VILLAGE OF MOUNT HOREB

PLAN COMMISSION/HISTORIC PRESERVATION COMMISSION AGENDA

To: Village of Mount Horeb Plan Commission
From: Village Planner Ben Rohr, AICP
Date: May 24, 2023
Re: Specific Implementation Plan (SIP) and Design Review for the Proposed 1-Story 1,910 sf Building Addition at 1991 Commerce Drive for Academy of Little Vikings.

COMMENTS		DATE		#	
REVISIONS					
DRAWN BY : LB		DATE : MAY 02, 2023		SCALE : 1/8" = 1'-0"	
ACADEMY OF LITTLE VIKINGS		MADISON, WISCONSIN		SITE LIGHTING LAYOUT

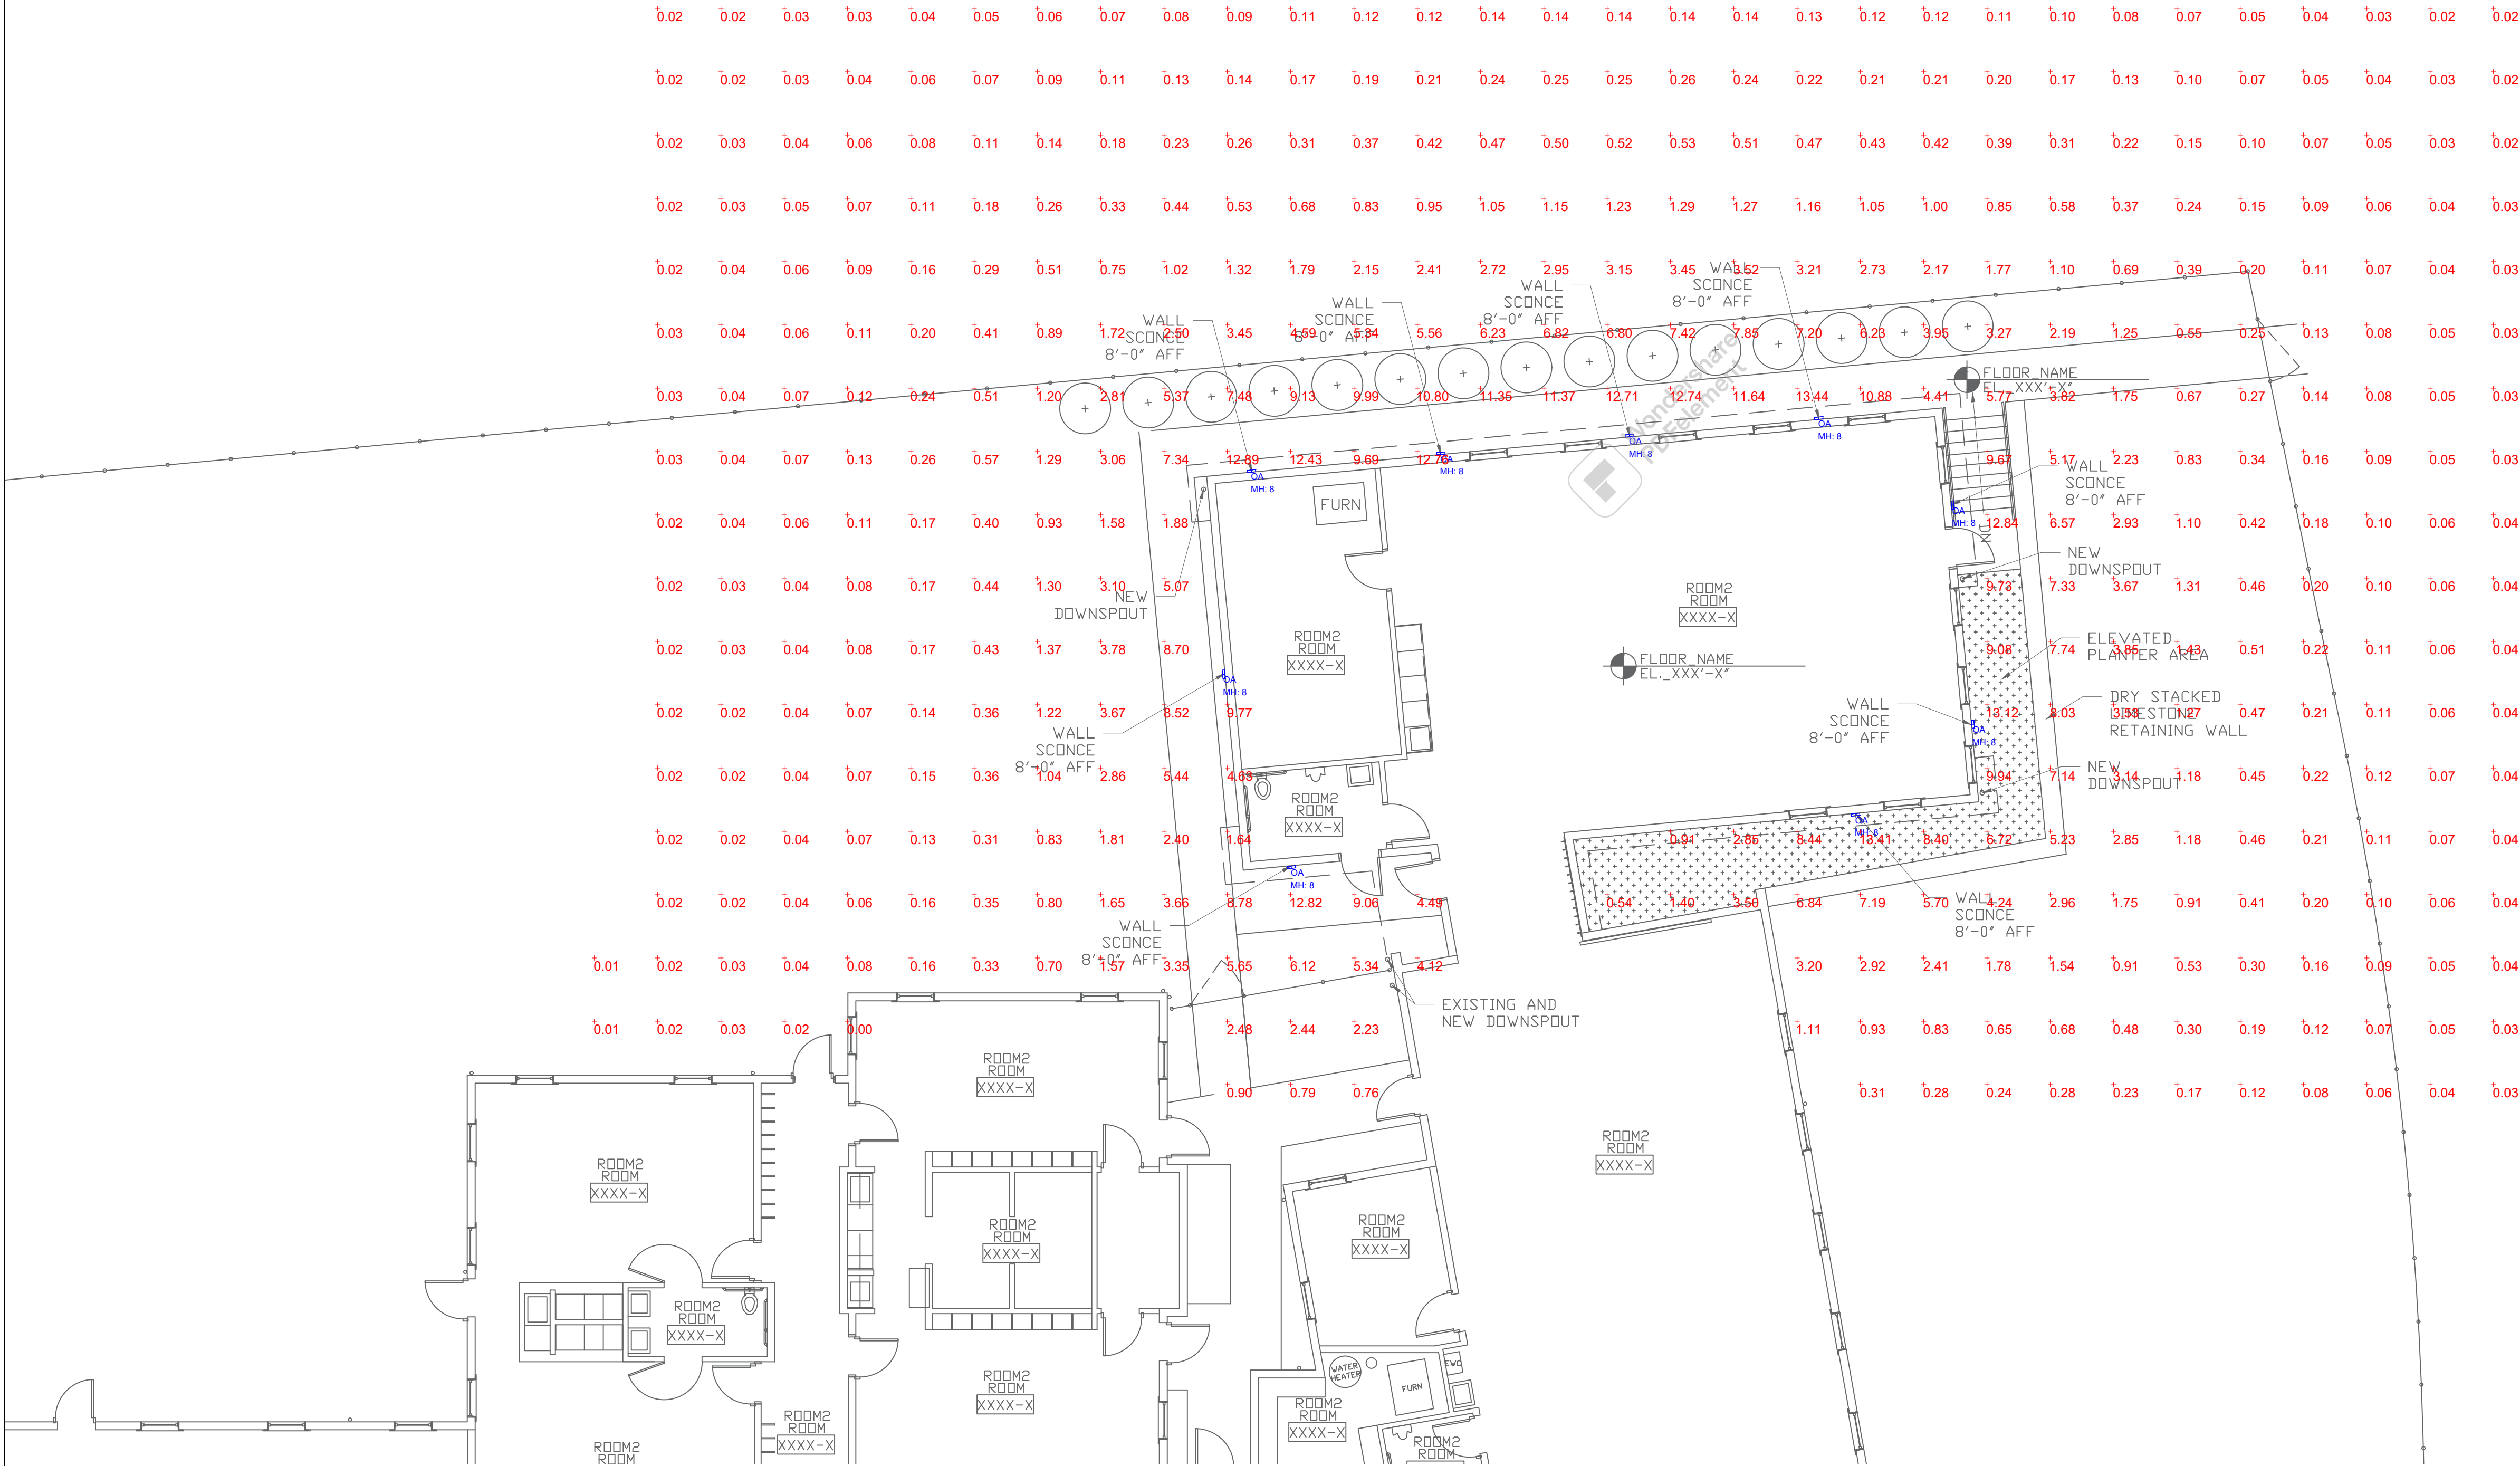
- This requirement is met.
- c. Lighting at the property lines shall not exceed 0.5 footcandles over ambient conditions.
 - This requirement is not met. The Lighting Plan shows footcandles in excess of 7.0 at the northern property line. I recommend waiving this requirement in conjunction with my comments below in d. With only 9 feet between the building addition and the northern property line, it may not be possible to meet the 0.5 footcandle standard, but the fixtures could be changed to reduce the amount of footcandles emitted from each fixture that would result in this being less of a concern.

- b. 18.c. for allowing greater than 0.5 footcandles to be emitted at the northern property line, only if the requirements of 4. below are met.
4. Require the applicant to update the Lighting Plan with different fixtures proposed on the building addition to reduce the footcandles emitted from each in compliance with the Village Zoning Ordinance (maximum of 10.0 on-site). Village staff review and approval of a revised Lighting Plan.
